To all users of the following systems: Cios VA30

Product/Trade Name:	Cios Spin, Cios Alpha, Cios Flow	EU-SRN	DE-MF-000006122
UDI-DI:	04056869153506, 04056869153490, 04056869246628	E-mail	advancedtherapies-fsca.team@siemens-healthineers.com
		Date	September, 2023
		Corrective Action ID	AX036/23/S

Customer Safety Information (CSI) for Field Safety Corrective Action

Subject: Fulfillment of new requirements from DIN and IEC standards for Cios VA30 Systems

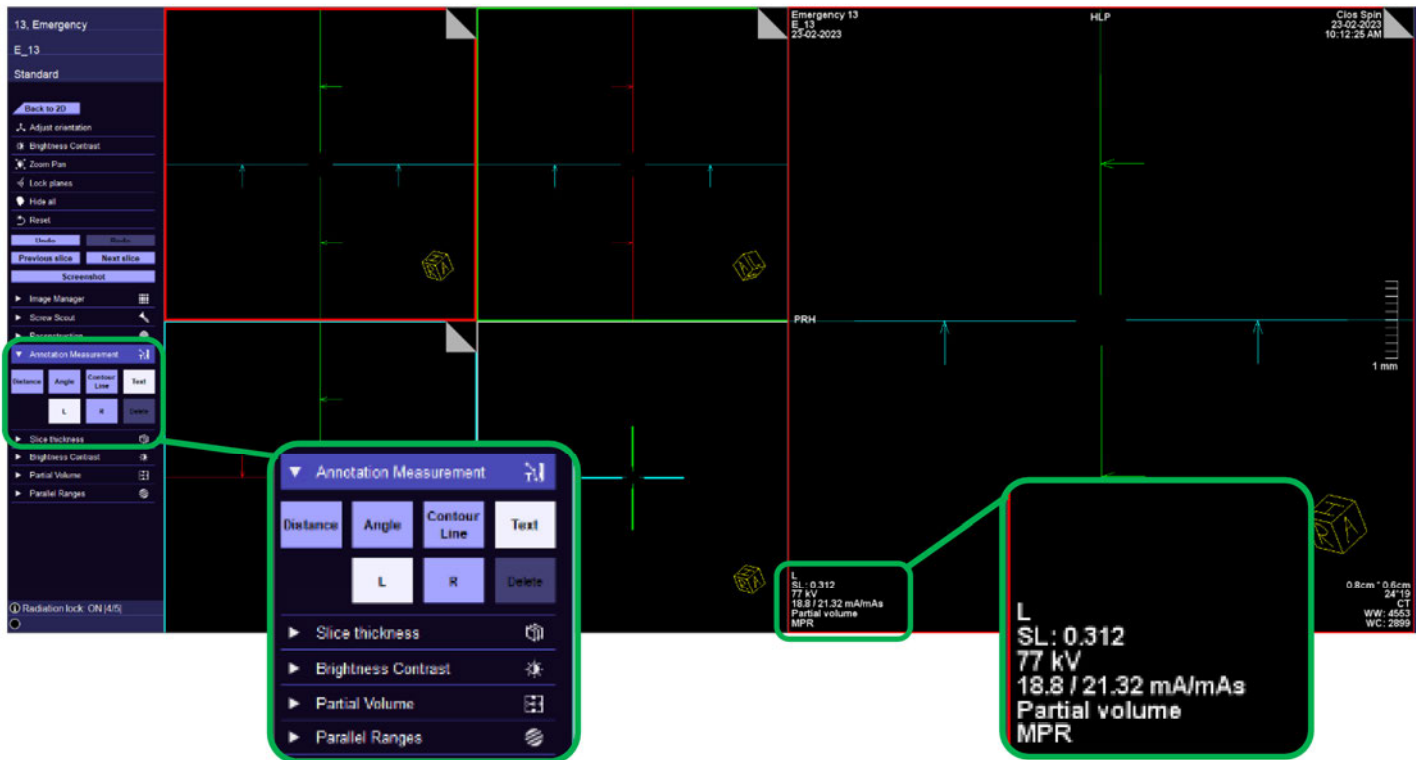
In 3D mode and if patient orientation information is important in a procedure, the user can predefine the patient orientation “L/R” (left/right), and therefore “laterality” information will additionally be saved in the clinical image (see screenshot of user interface below).

In radiography modes SUB, DR, DCM as well as in 3D mode, the autostore function is selected/activated by default and cannot be deactivated by the user.

Our service organization will install a new software version VA30K.

With software version VA30K, the user interface of Cios VA30 systems will be changed to consider the current standards DIN 6862-3 and IEC 60601-2-54.
